Step 1/7 - Welcome to RANGER

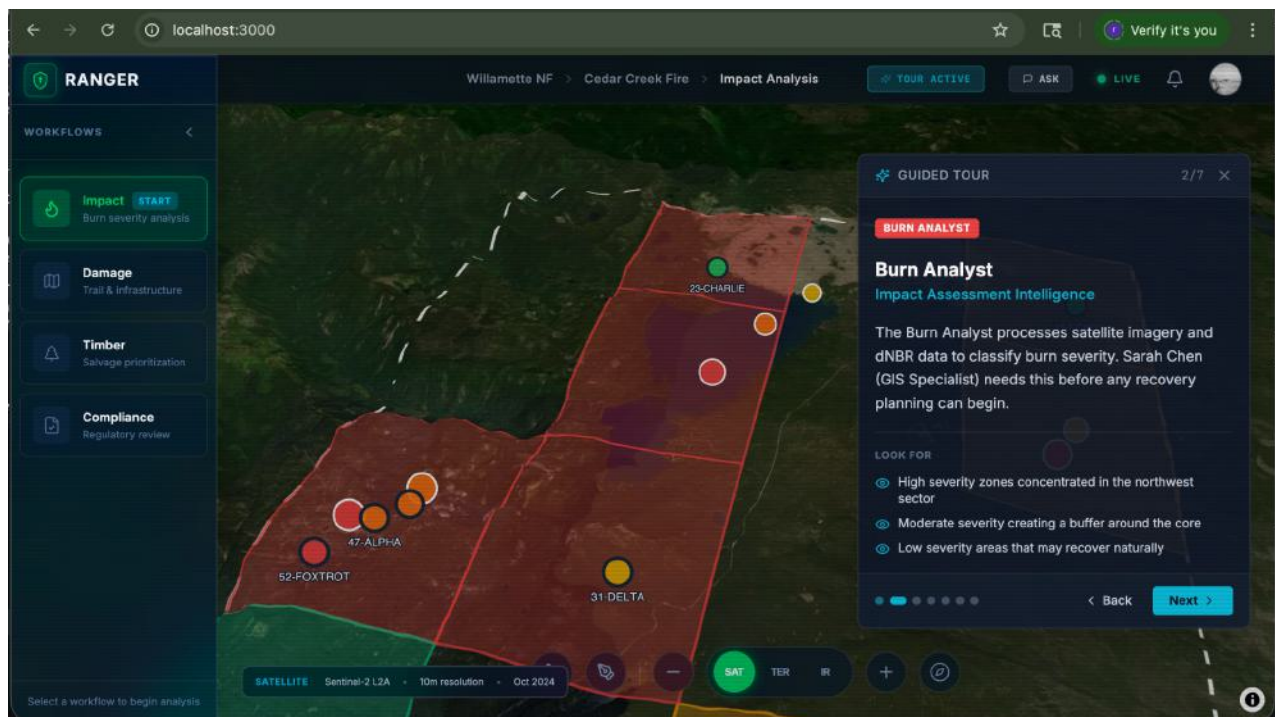
1. Subtitle - "The Nerve Center for Forest Recovery" is good, but could be punchier. Alternative: "AI-Powered Forest Recovery Operations"
2. The copy mentions "siloes data" - This is internal jargon. Consider: "RANGER orchestrates AI agents to turn complex data into clear recovery decisions."
3. "LOOK FOR" items - The 3D terrain bullet point may be confusing since the map appears 2D from this angle. Should we adjust the camera pitch to show terrain, or change the copy?
4. Map state - The timber plots (orange/yellow circles with labels like 47-ALPHA) are visible but not mentioned in the tour text. Should they be hidden at this step, or mentioned?
5. Sidebar shows "Impact START" - Good that it highlights where users will begin, but should the tour card point this out?

- Is the map camera position/zoom correct for this intro step?
- Should we simplify the copy or keep the detail level?
- Any elements on screen that feel distracting?

Step 2/7 - Burn Analyst

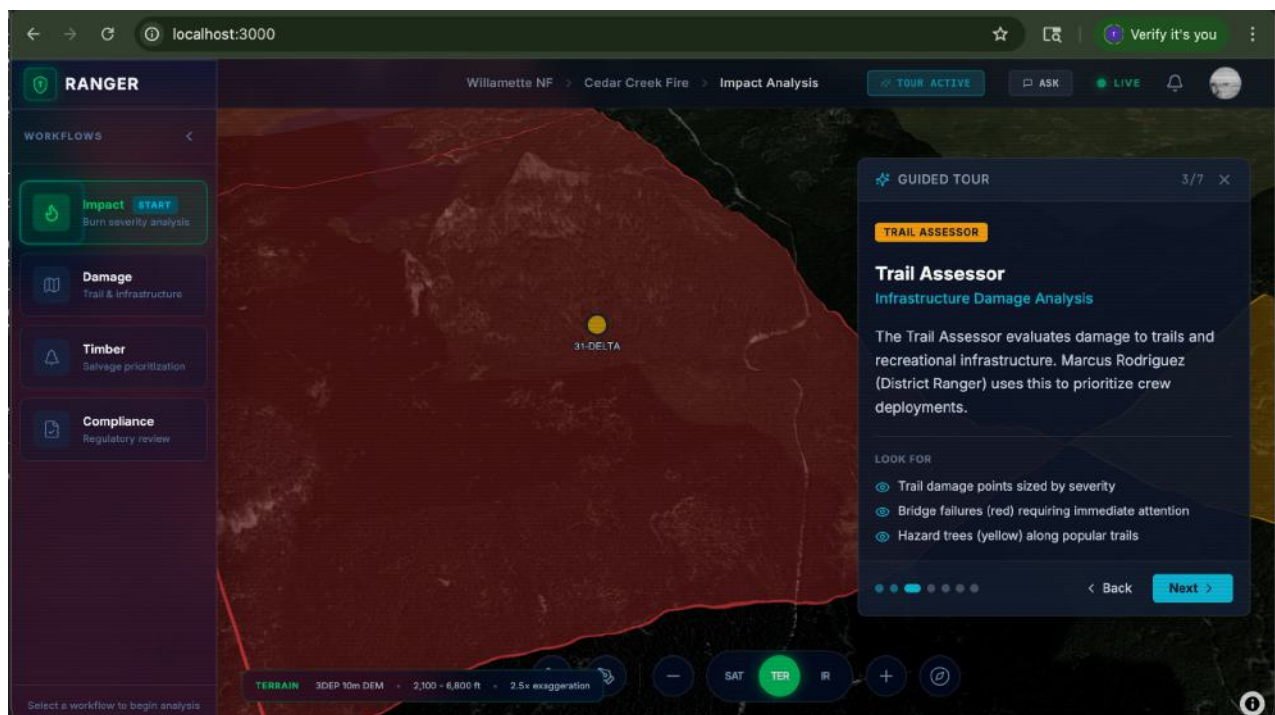
1. Title mismatch - Card says "Burn Analyst" but sidebar says "Impact". Earlier we standardized to "IMPACT ANALYST". Should be consistent.
2. Subtitle - "Impact Assessment Intelligence" is a bit generic. Could be more specific like "Burn Severity Classification"

3. Technical jargon - "dNBR data" won't mean anything to most viewers. Consider removing or explaining (differential Normalized Burn Ratio).
4. Timber plots visible - The orange/red/yellow circles (47-ALPHA, 52-FOXTROT, 31-DELTA, 23-CHARLIE) are timber plots, not burn severity. They could confuse viewers since we're talking about severity zones. Should they be hidden for this step?
5. Camera position - Good zoom level, shows the high severity (red) areas clearly in the northwest
6. Small UI detail - There's a floating pink/red circle near "LOOK FOR" section
 - is that intentional or a rendering artifact?

Step 3/7 - Trail Assessor

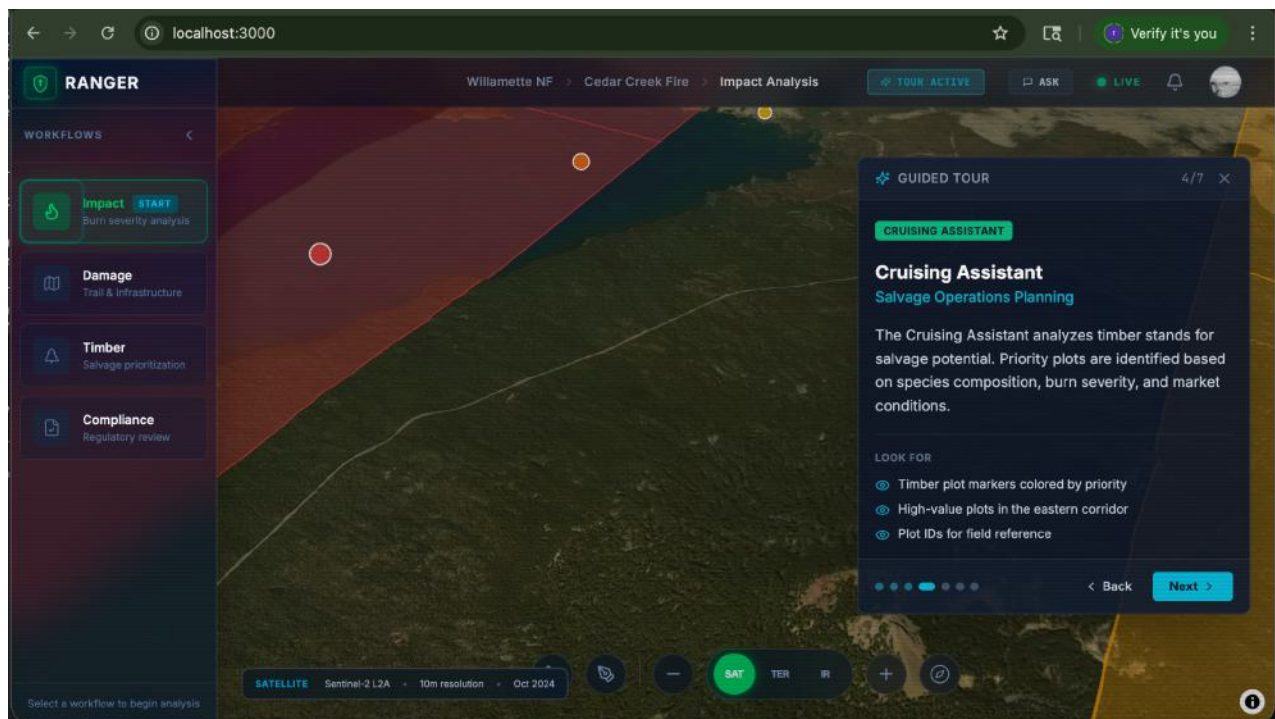
1. Major issue: Map doesn't match copy - The "LOOK FOR" section mentions trail damage points, bridge failures (red), and hazard trees (yellow), but the map only shows one yellow

marker (31-DELTA) which appears to be a timber plot, not trail damage. Where are the trail damage markers?

2. Title mismatch again - Card says "Trail Assessor" but we standardized to "DAMAGE ASSESSOR". Sidebar says "Damage" which is closer.
3. Sidebar not highlighted - The "Damage" workflow in sidebar isn't visually activated/highlighted like "Impact" was in the previous step. Should it pulse or highlight?
4. Camera position - Zoomed out quite a bit. If we're looking at trail damage points, should we zoom to where they actually are?
5. Layer choice - TER mode is good for showing terrain/trails, but the desaturated colors make it harder to see markers. Is this intentional?
6. Badge color - "TRAIL ASSESSOR" badge is gray/neutral. Should it have a distinct color like amber to match the Damage workflow theme?

Step 4/7 - Cruising Assistant

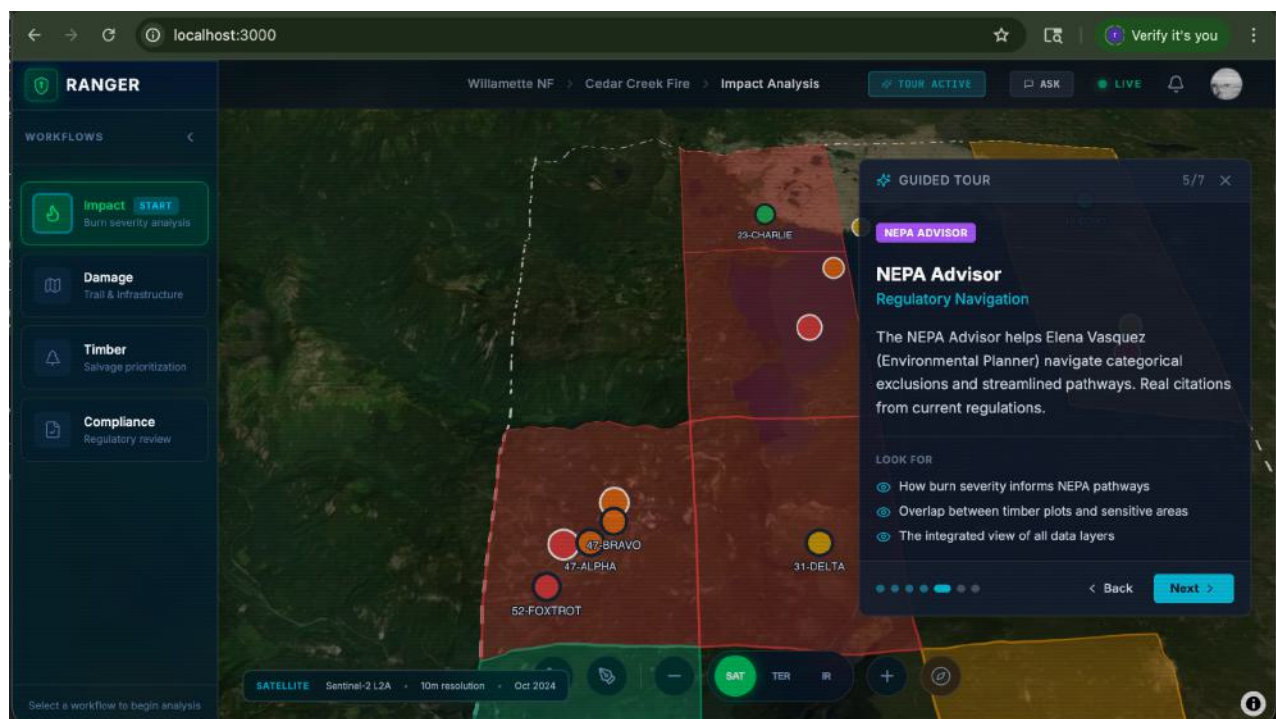
1. Title mismatch - Card says "Cruising Assistant" but we standardized to "TIMBER ANALYST". Sidebar says "Timber".
2. Missing plot labels - Copy mentions "Plot IDs for field reference" but I don't see labels like 47-ALPHA, 52-FOXTROT visible on this view. They were visible in earlier steps.

3. Camera position - Good that it shows multiple plots, but "high-value plots in the eastern corridor" is mentioned - are we looking at the eastern corridor? Hard to tell without orientation.

4. No persona - Steps 2 and 3 had personas (Sarah Chen, Marcus Rodriguez). This step doesn't. Inconsistent pattern - either all steps should have personas or none.

5. Sidebar not highlighted - "Timber" workflow should be visually highlighted/active for this step.
6. Burn severity zones - The red overlay is visible but we're not talking about it here. Could be distracting, or could be helpful context showing the relationship between burn severity and timber plots.

Step 5/7 - NEPA Advisor

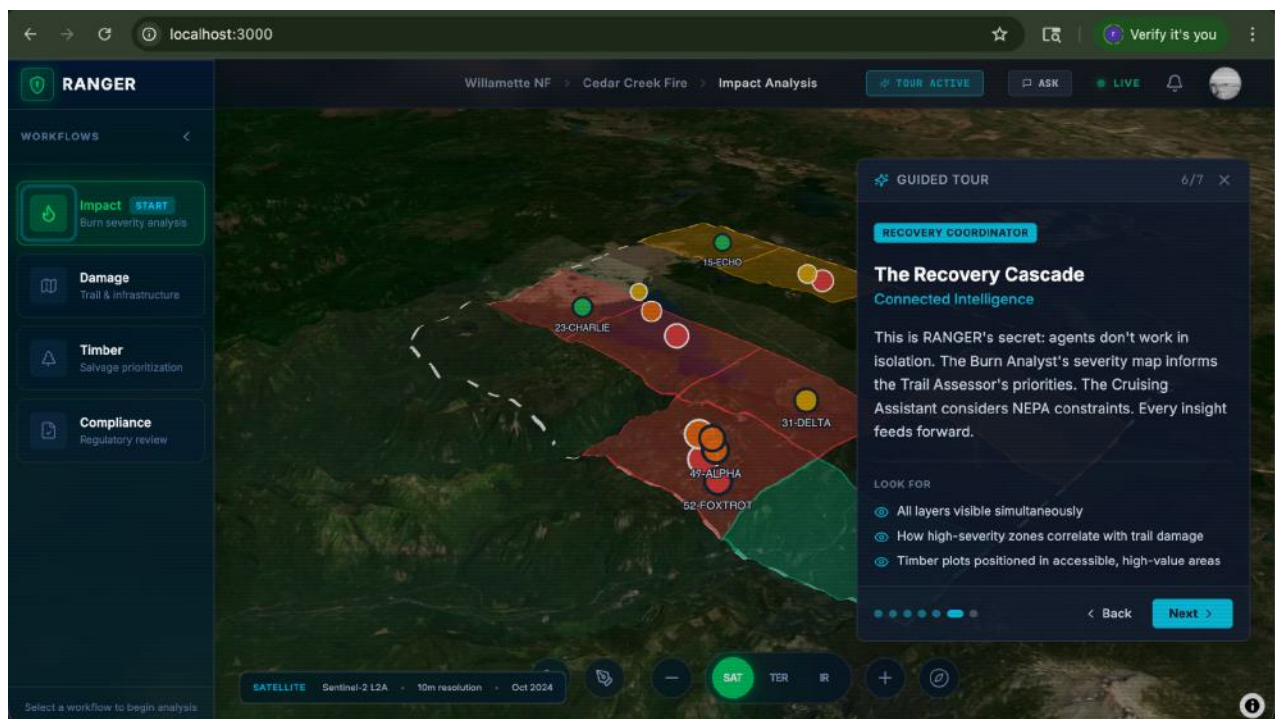
1. Title mismatch - Card says "NEPA Advisor" but we standardized to "COMPLIANCE ADVISOR". Sidebar says "Compliance".
2. Map shows everything - This is appropriate for compliance (seeing the full picture), but could feel cluttered. The "integrated view of all data layers" bullet acknowledges this.

3. Sidebar not highlighted - "Compliance" workflow should be visually active.
4. Abstract "LOOK FOR" items - Unlike previous steps with concrete visuals (red zones, markers), these are conceptual: - "How burn severity informs NEPA pathways" - hard to see on map - "Overlap between timber plots and sensitive areas" - where are sensitive areas shown? - "The integrated view" - okay, but vague

5. New plot visible - "47-BRAVO" appears for the first time (red marker next to 47-ALPHA). Is this intentional? Different from previous steps.
6. Subtitle - "Regulatory Navigation" is good, though "Compliance Review" might be more concrete.

Step 6/7 - The Recovery Cascade

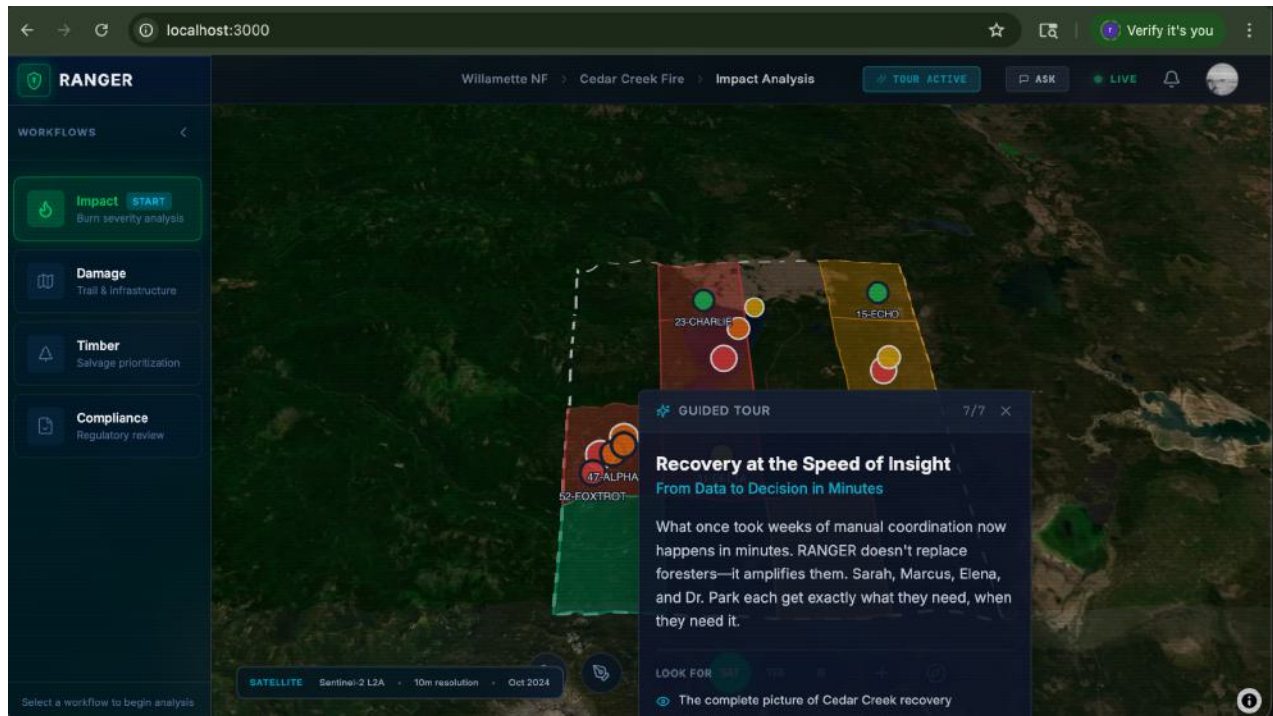
1. This is the synthesis step - Works well as the penultimate step showing how everything connects. Good narrative flow.
2. Badge says "RECOVERY COORDINATOR" - This matches our naming. Good!
3. Trail damage markers visible - I can see green, yellow, orange, red circles that appear to be damage markers near 23-CHARLIE and 15-ECHO area. These were missing in Step 3 but visible here.
4. Copy uses old agent names - "Burn Analyst", "Trail Assessor", "Cruising Assistant" - should these be updated to IMPACT ANALYST, DAMAGE ASSESSOR, TIMBER ANALYST for consistency?
5. Strong narrative - "agents don't work in isolation" and "Every insight feeds forward" - excellent messaging that sells the orchestration value.
6. Sidebar still shows Impact as active - Should all four workflows be highlighted here since we're showing the full cascade?
